Scrambled idle error checker

Pete Anslow, Nortel Networks
IEEE P802.3ba, New Orleans, January 2010

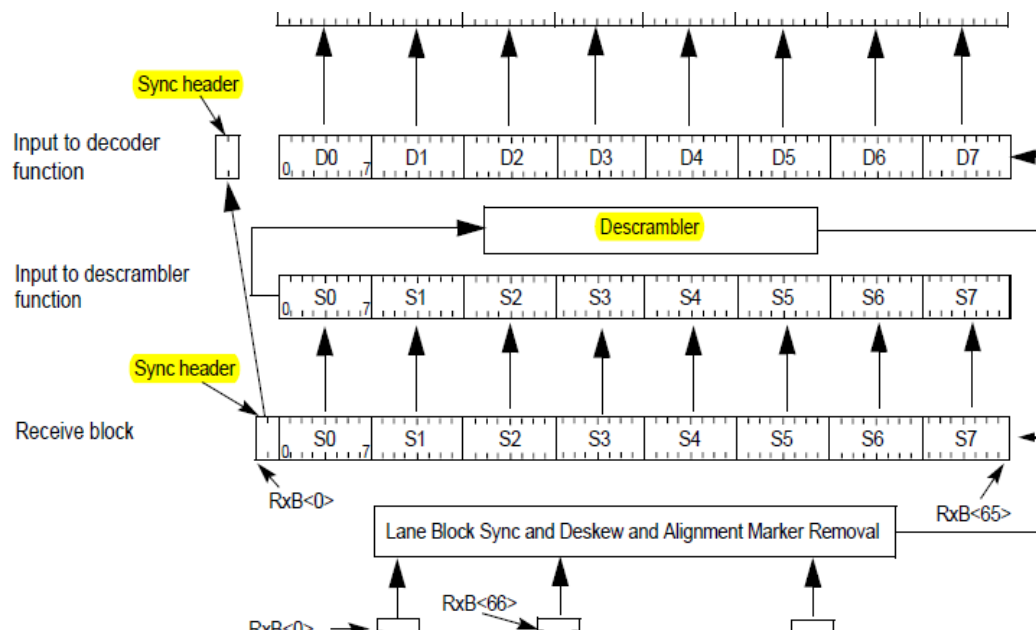
Sync bits

But according to Figure 82-4, the sync bits bypass the descrambler.

So, are the sync bits checked for errors or not?

To make this checker and the BIP checker cover the same bits we should explicitly include the sync bits.

Descrambler error multiplication

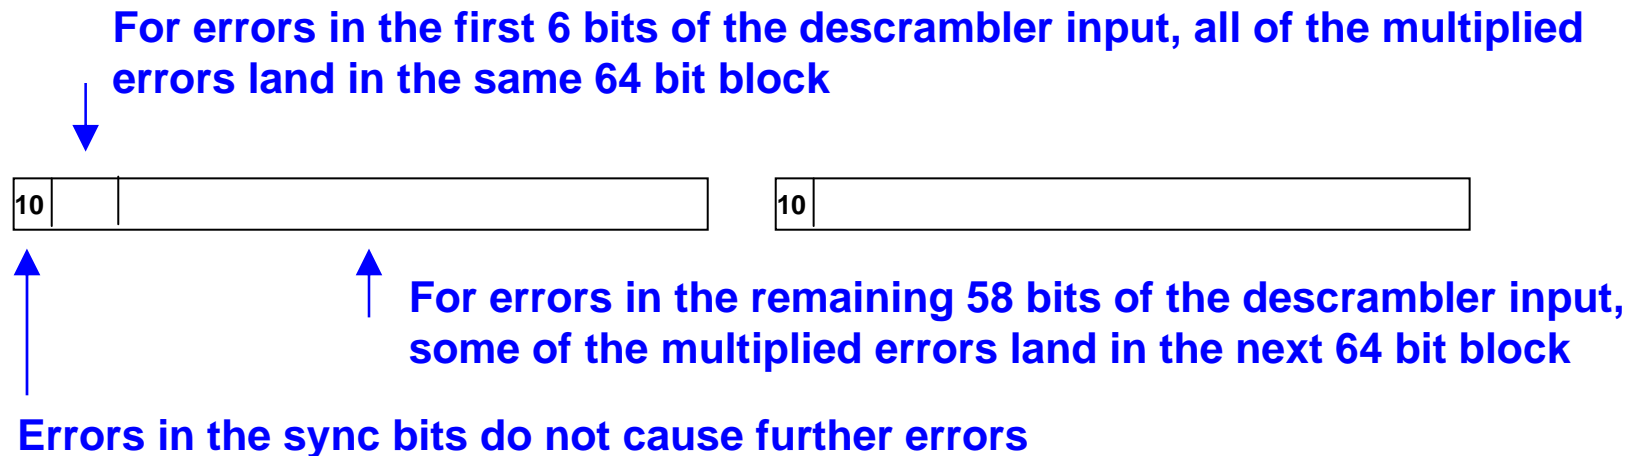
The descrambler defined in 82.2.15 generates three errors at its output for every isolated error at its input. These are 39 and 58 bits after the input error.

Consequently, the bit error ratio is the block error ratio divided by a factor of $66 \cdot (1 + 58/66)$. i.e. the BER = block error ratio / 124

Error checker performance

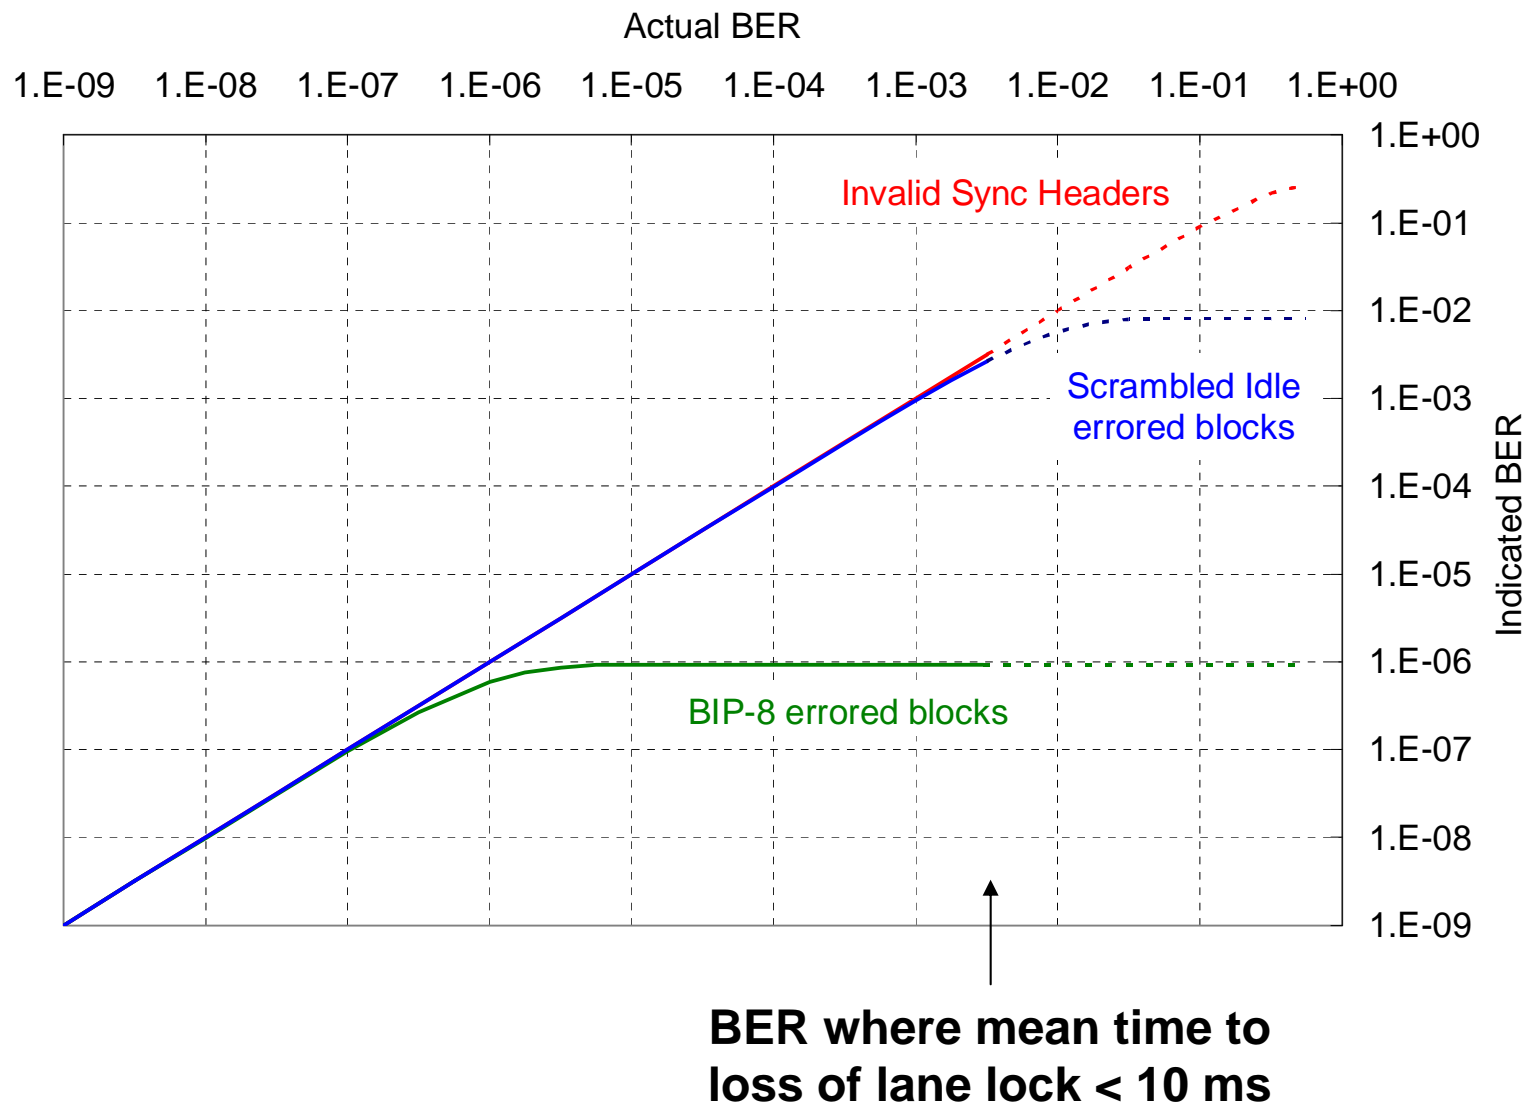
Proposal in comment #461

Change the text in 82.2.17 as below:

When `align_status` is true and the scrambled idle receive test-pattern mode is active, the scrambled idle test-pattern checker observes the [sync header and the](#) output from the descrambler. When the [sync header and the](#) output of the descrambler is the all idle pattern, a match is detected. When operating in scrambled idle test pattern, the test-pattern error counter counts blocks with a mismatch. Any mismatch indicates an error and shall increment the test-pattern error counter. [Because of the error multiplication characteristics of the descrambler, the incoming bit error ratio can be estimated by dividing the 66-bit block error ratio by a factor of 124.](#)

Change the text in 82.2.14 as below:

As part of the alignment marker removal process, the BIP_3 field is compared to the calculated BIP value for each PCS lane. If a Clause 45 MDIO is implemented, then the appropriate BIP error counter register (registers 3.90 through 3.99) is incremented by one each time the calculated BIP value does not equal the value received in the BIP_3 field. [The incoming bit error ratio can be estimated by dividing the BIP block error ratio by a factor of 1 081 344.](#)
